Spare headlight

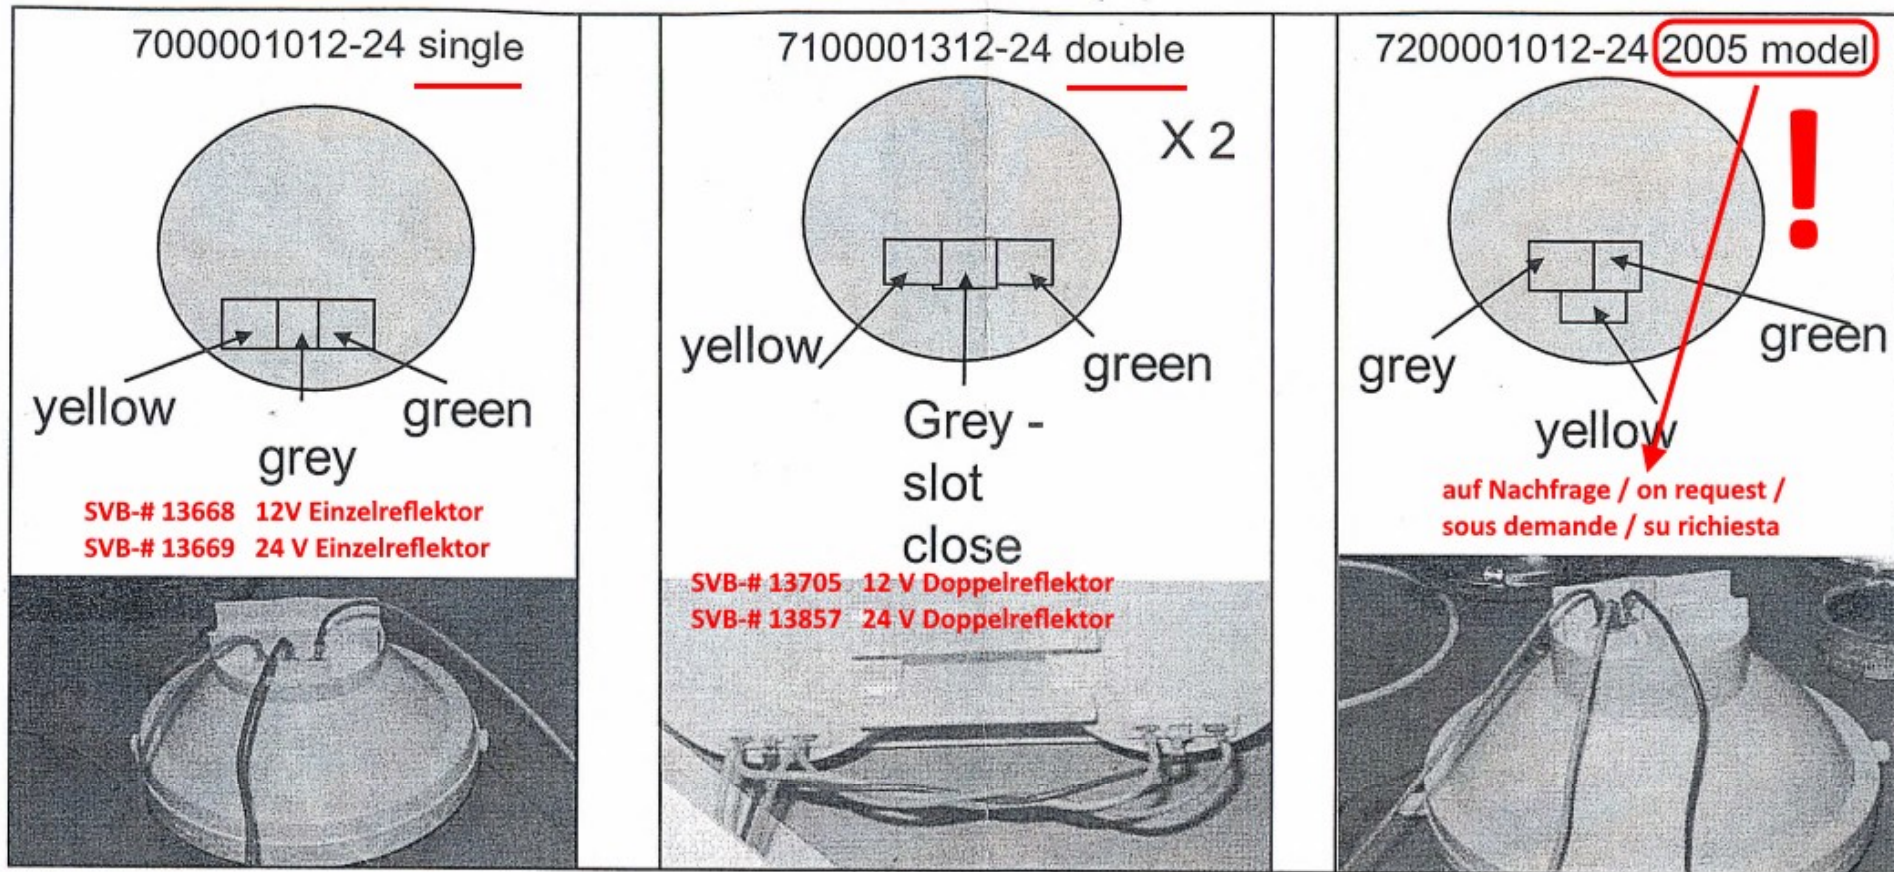
Each cable has its position and needs to respect cable colour in each slot, yellow = common.
NOTE FOR THE DOUBLE VERSION: Starting from 2017 in the deliveries of the 7100001312-24 there is an halogen version (only with 1 filament) to increase the lifetime of the bulb, So the grey cable included in the spotlight doesn't need to be connected. The remote control Will work in on (lever up) – off position and not in on-off-on as before. For the other 2 single version green cable is related to the spot type of light and grey to the deep type of light
